SI B11 07 12 Engine

This Service Information bulletin supersedes SI B11 07 12 dated July 2012.

SUBJECT N63 Engine: Oil Consumption and/or Rough Running Complaints

MODEL E70	
E71	
F01	
F02	
F04	
F07	
F10	
F12

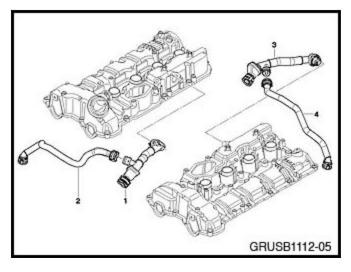
The construction material of the crankcase ventilation connection lines and vent pipes may become brittle from engine compartment temperatures.

3. If the index number is "7" or lower, both crankcase ventilation connecting lines and vent pipes need to be replaced.

> The improved replacement parts will have an index of "8" or higher.
